SUBJECT: Forwards open items from Structural Engineering Branch
 811005-08 meeting in Woodbury, NY.

Subject: NUCLEAR PROJECT NO. 2
OPEN ITEMS FROM SEB MEETING

Attached are sixty copies of the open items from the Structural Engineering Branch meeting held in Woodbury, New York, October 5 - 8, 1981.

WNP-2
NRC-SEB MEETING

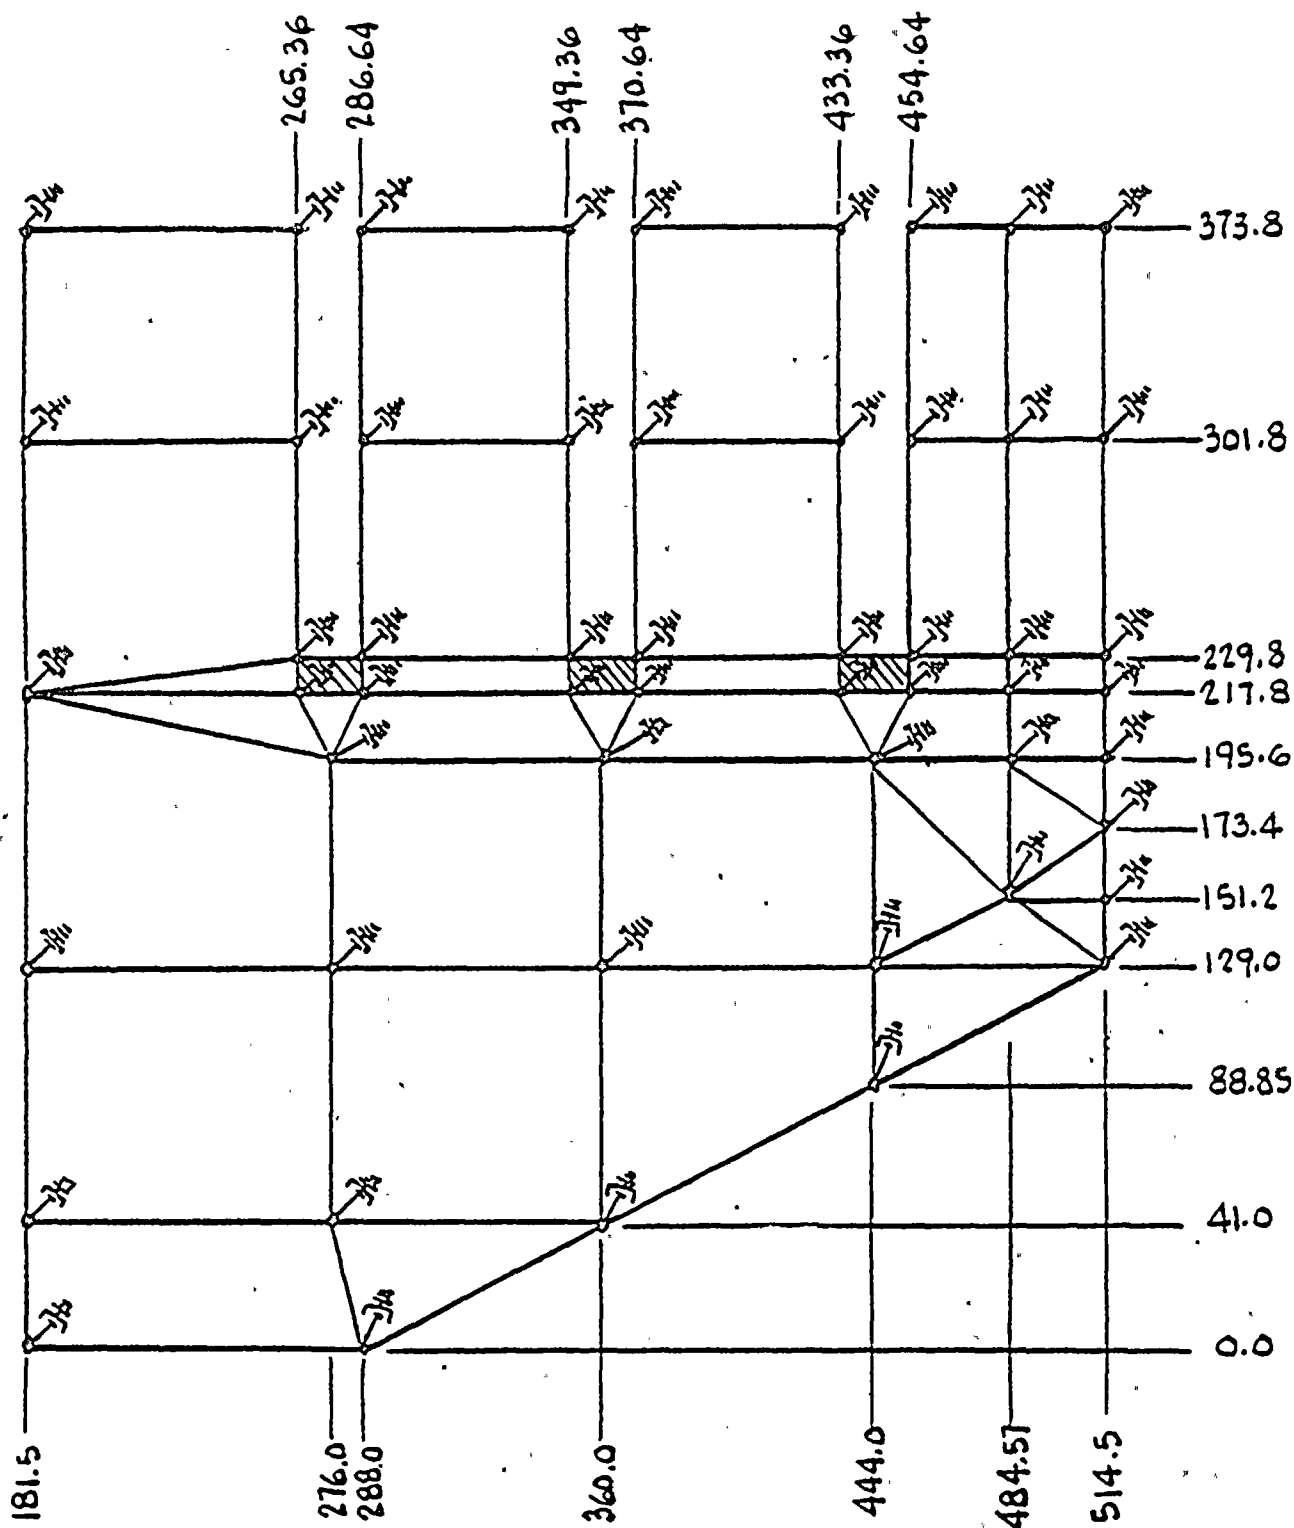
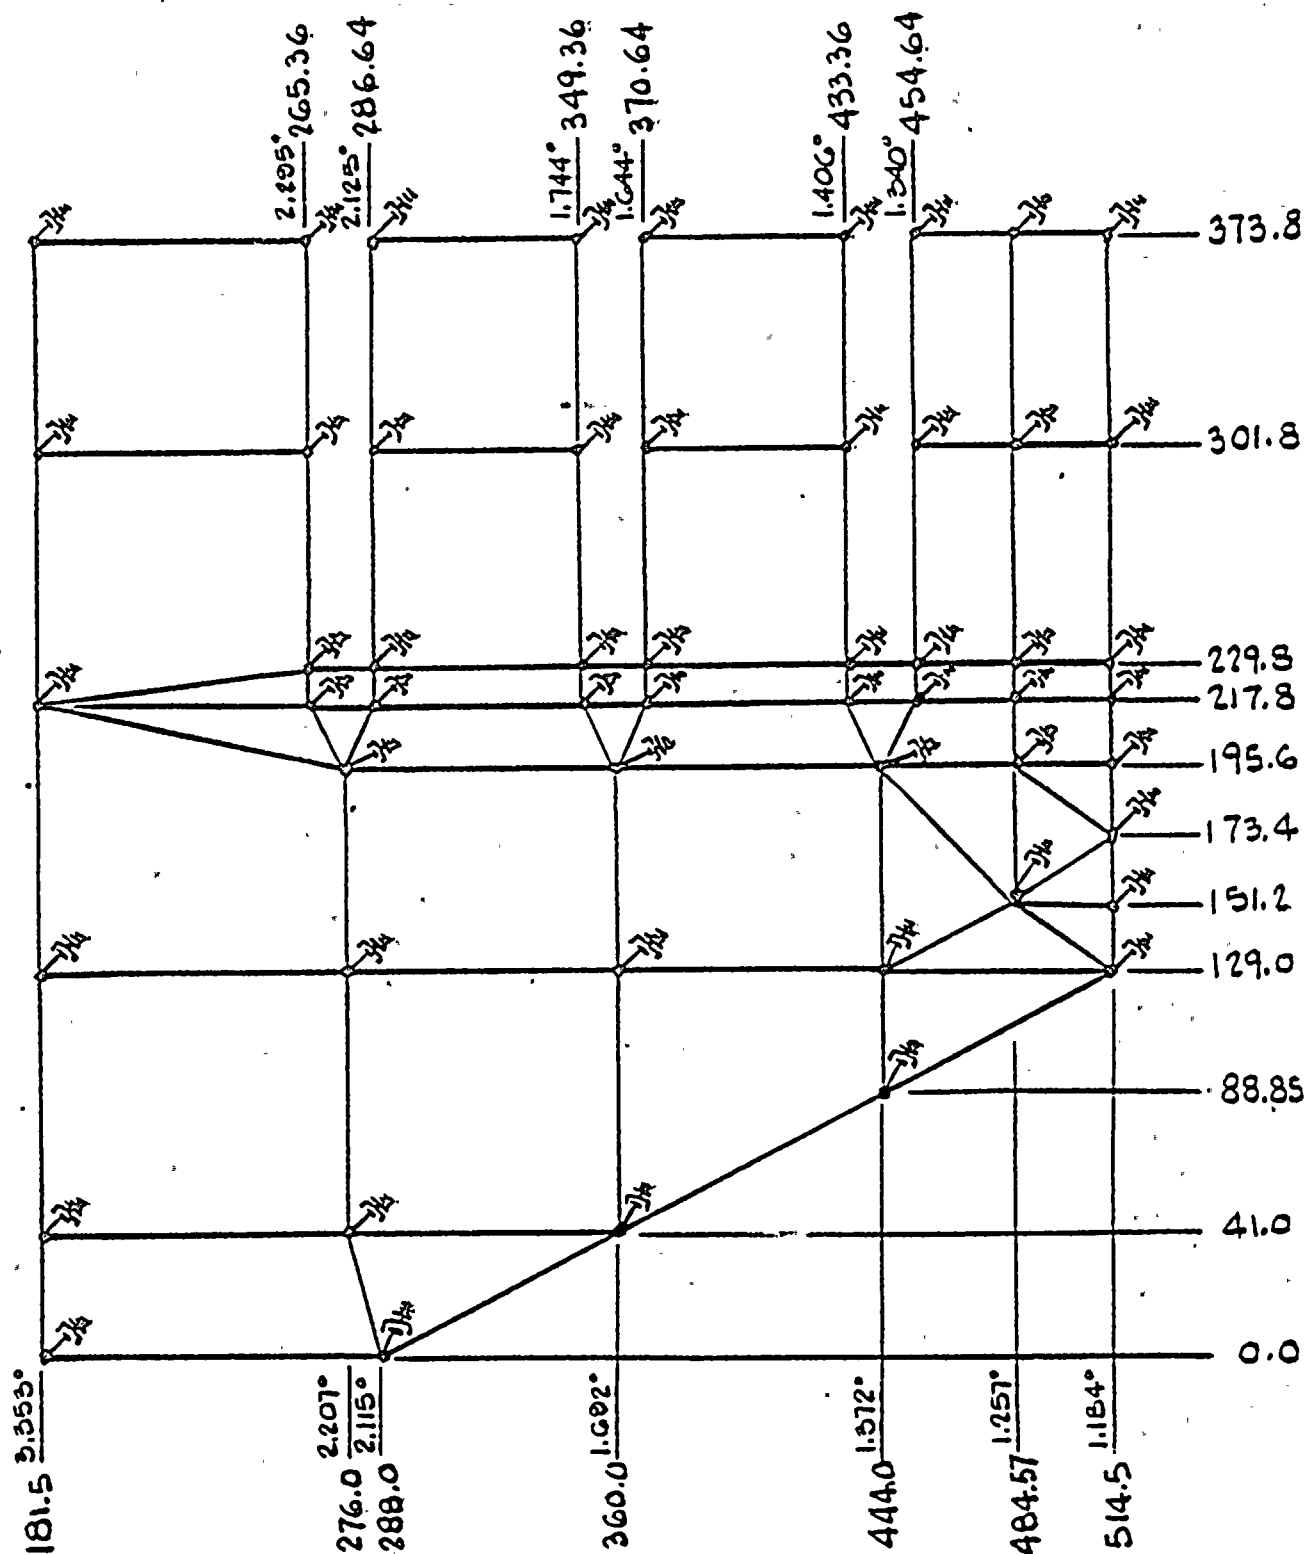
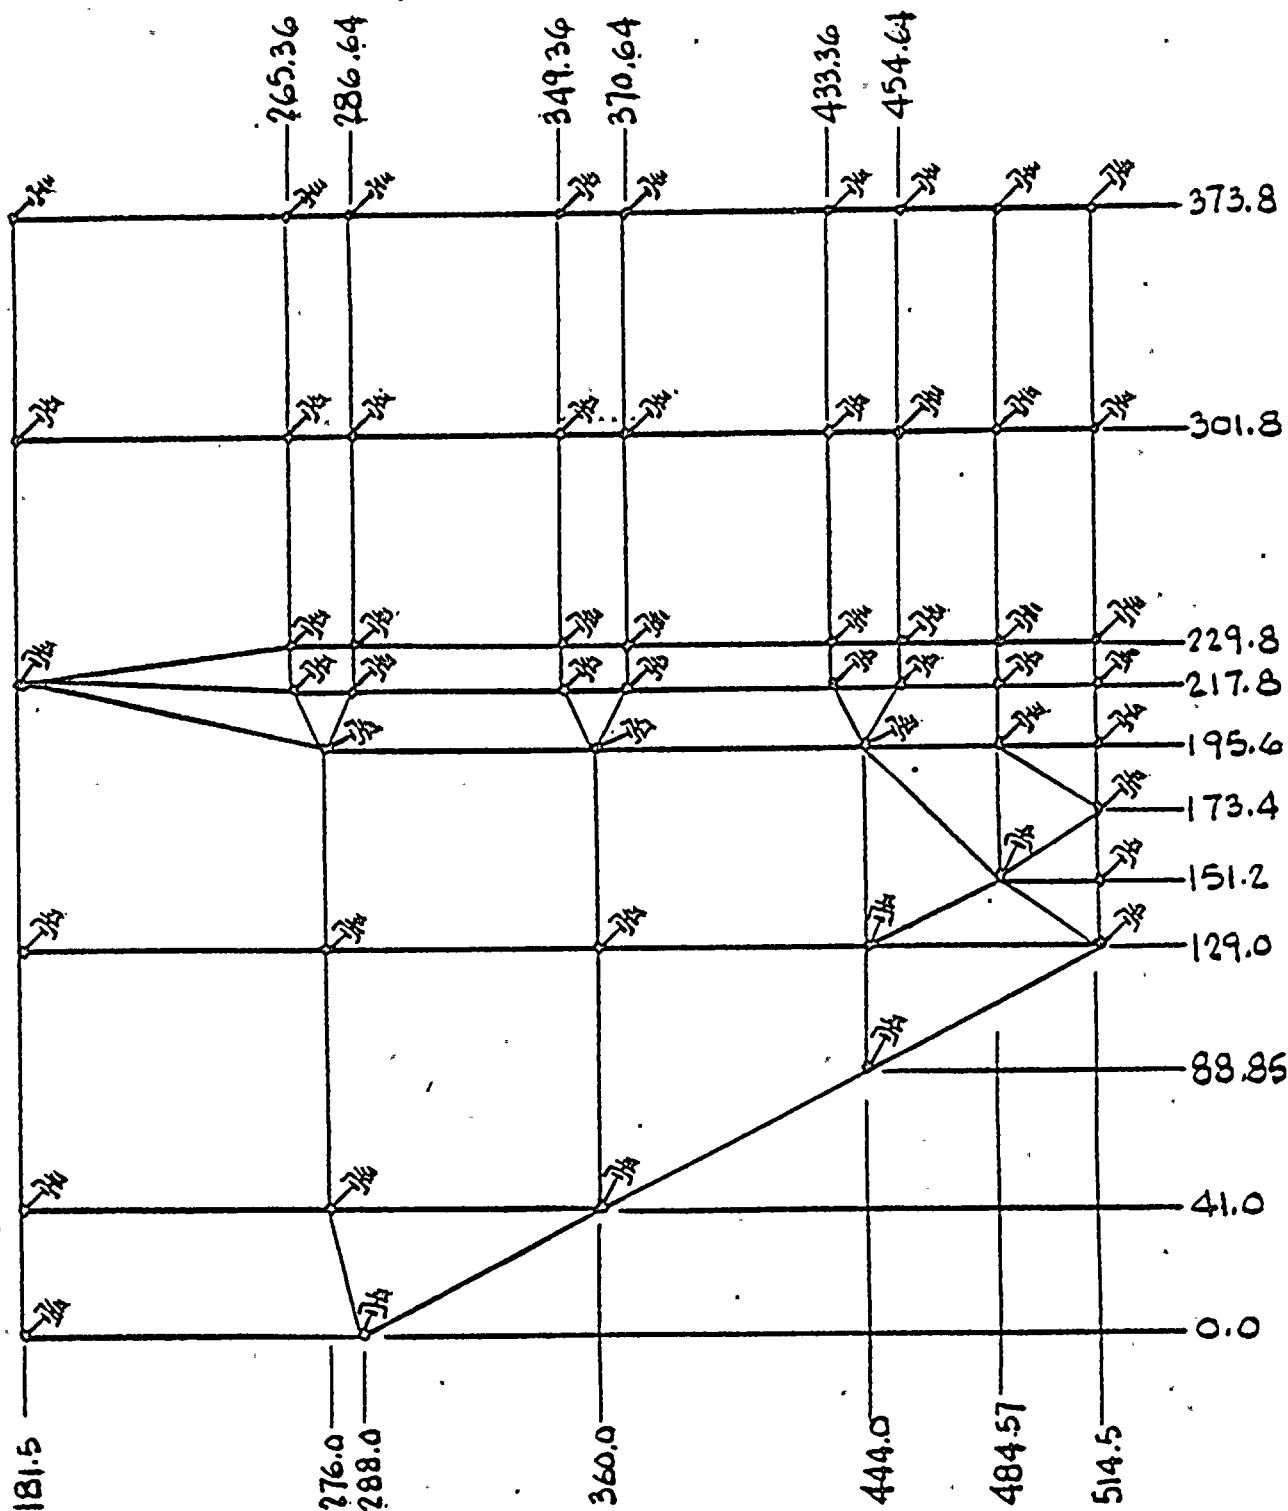
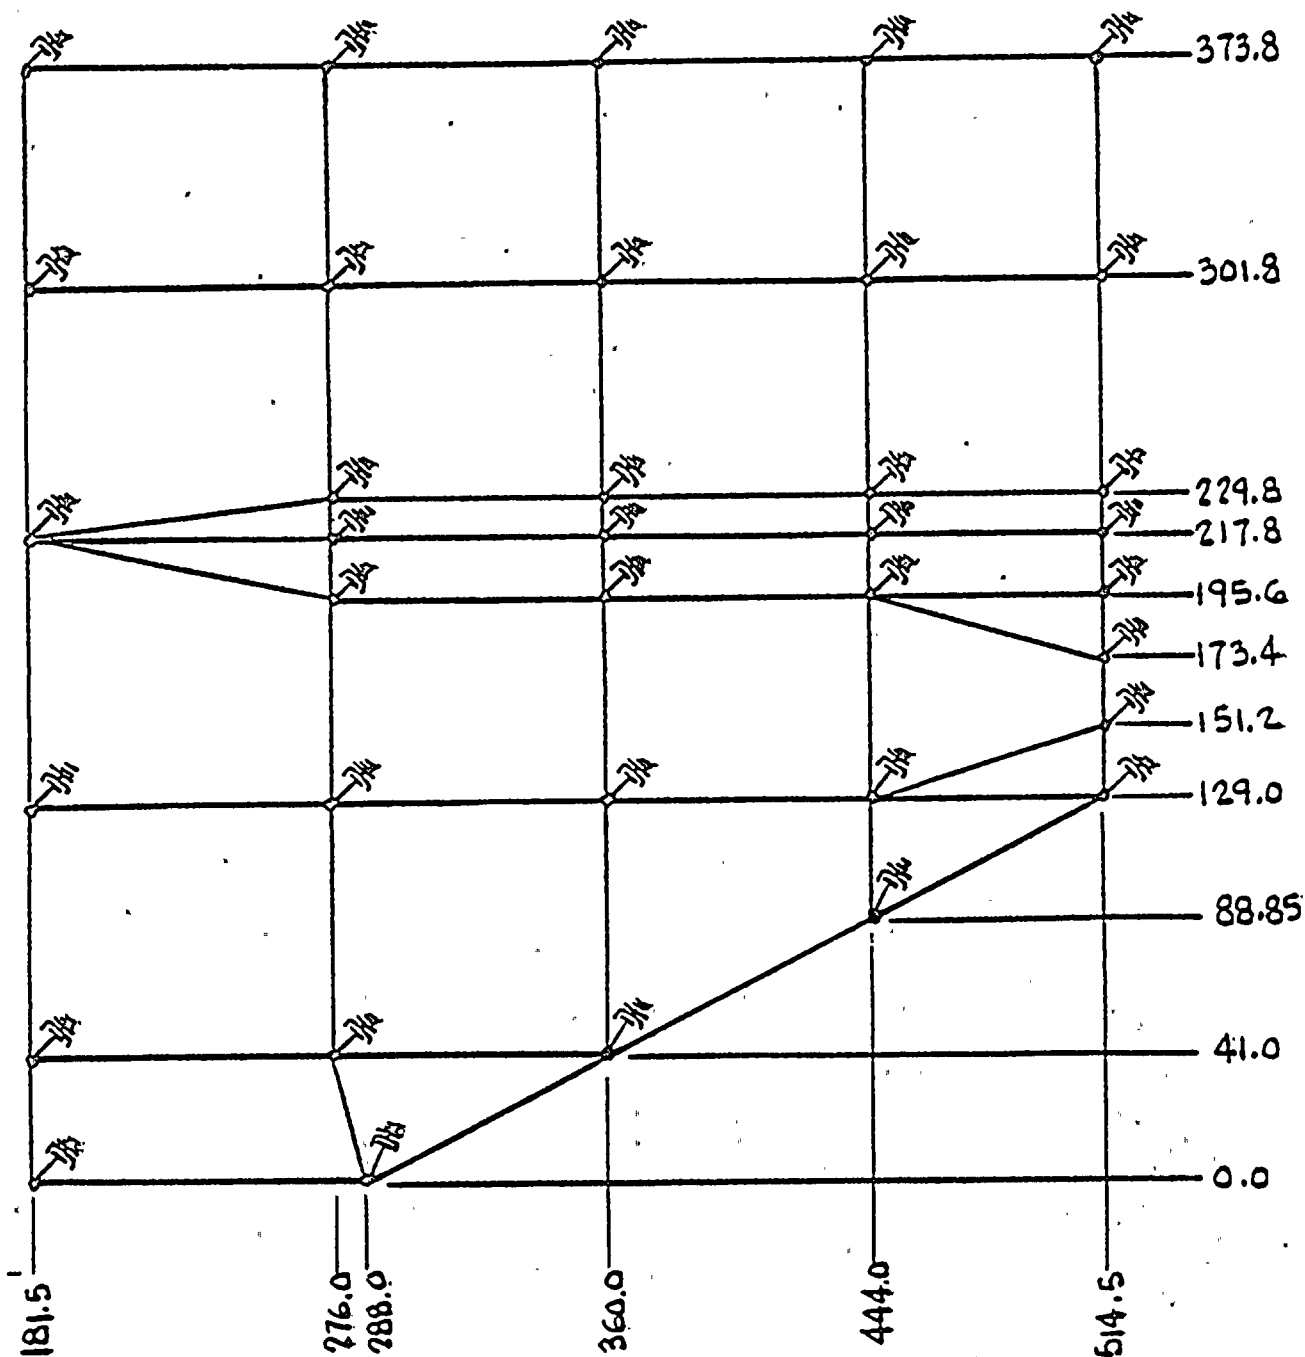
In the theoretical formulation of the equation for the fluid-structure interaction analysis as indicated in Section 5.2 of the report, a so called dynamic stiffness matrix is defined in terms of M_s , M_a , C_s and K_s matrices. Provide a discussion how the structural damping matrix C_s is established, and why the natural frequency of the structure is not involved in the formulation. In the model shown in Figure 5-4, no water is indicated, therefore, how M_a is considered? Provide a model used in the analysis which includes all the physical elements as contained in equation 5.3 of the report. How do you verify the validity of your theoretical formulation?

Different element damping matrices C_s^n can be assembled using the conventional assembling finite element method technique to form the total structural damping matrix C_s . Since C_s^n is formed for each individual element, it is non-proportional damping matrix thus it is independent from the structural natural frequencies. It insures that the loss of energy due to damping in each individual element is constant over all frequencies, Ref. 130.073.1.

The hydrodynamic added mass matrix M_a was computed using the hydrodynamic finite element model of Figs. 5.3 and 5.4 of B&R chugging report. The theoretical formulation of the model is described in detail in Appendix 5.1 of Ref. 130.073.2. The theoretical formulation was verified against the program NASTRAN, Ref. 130.073.3. Also, in Ref. 130.073.2 it was shown that this formulation can predict quite well the general behavior of the 4T test facility during chugging tests.
